GROUP <b>CHA</b>	MODEL <b>2011~2016MY Sportage (SL) 2011~2015MY Sorento (XMa)</b>
	NUMBER <b>047</b>	DATE <b>April 2015</b>
<b>TECHNICAL SERVICE BULLETIN</b>		
<b>SUBJECT: AWD SYSTEM HYDRAULIC ACTUATOR REPLACEMENT</b>

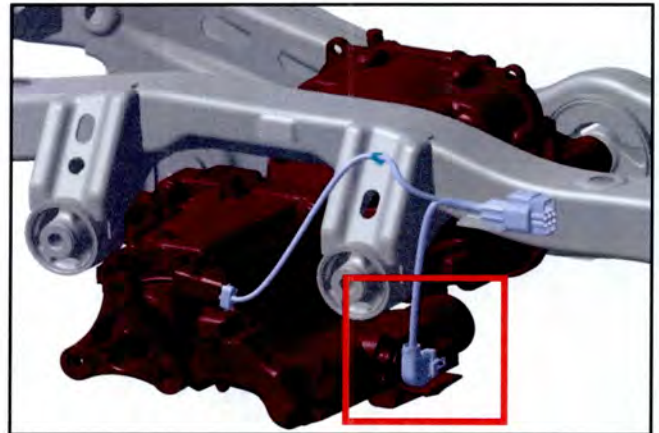
1. Replace the affected hydraulic actuator with a new one by referring to "4 Wheel Drive System→ Coupling Assembly → Oil Hydraulic Motor (Actuator) → Repair Procedures" chapter in the applicable Workshop Manual. **NOTE: To avoid fluid leaks, do NOT replace the actuator while coupling assembly is installed in the vehicle.**

To prevent any fluid leaks, hold the coupling assembly upright when replacing the Hydraulic Actuator. There is no replacement fluid allowance for this repair.
